Brake pads

8DB 355 011-401 / 8DB 355 015-961

Changed brake pads

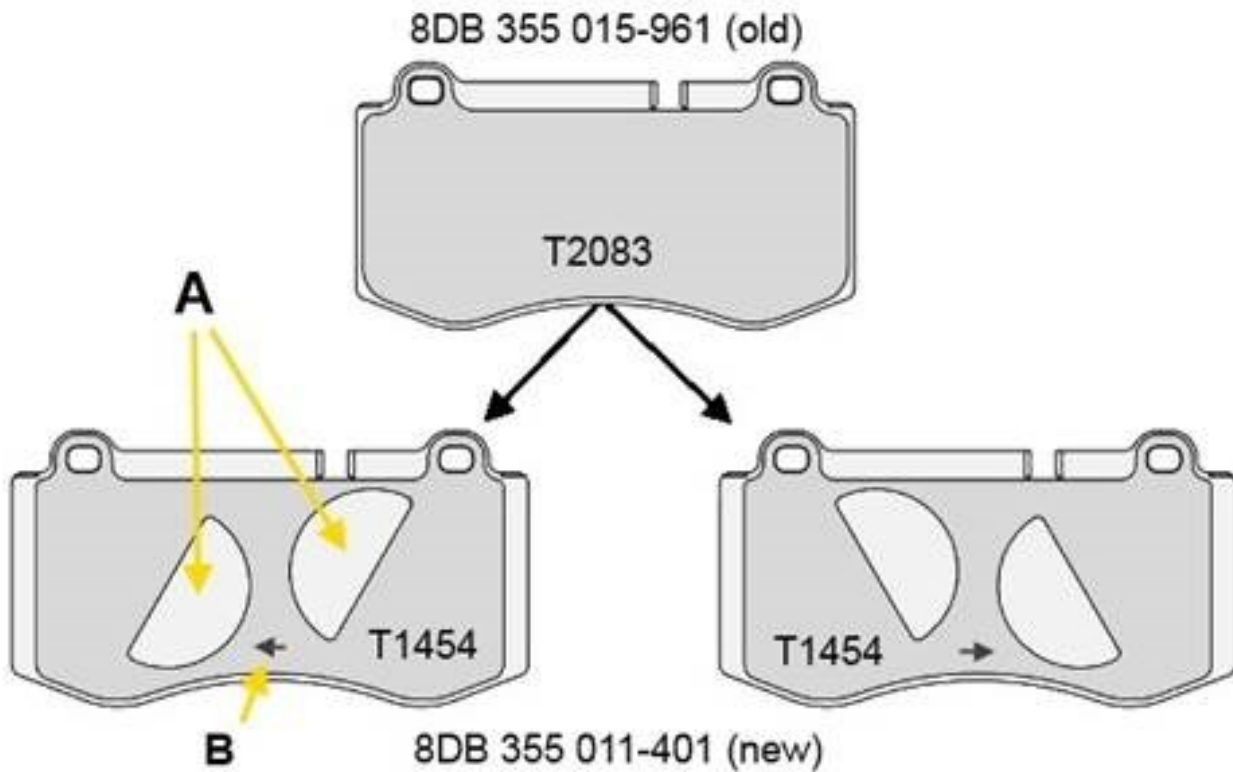
Brake pad 8DB 355 015-961 / T2083 will be replaced by brake pad 8DB 355 011-401 / T1454.

The difference between both brake pads is a change to the damping plate on the back plate of the brake pad. This change improves the noise sensitivity and thus, the comfort properties of the brake pads.

A new driving direction-related installation is necessary for the new damping plate with recess (A). The installation direction is indicated by an arrow (B).
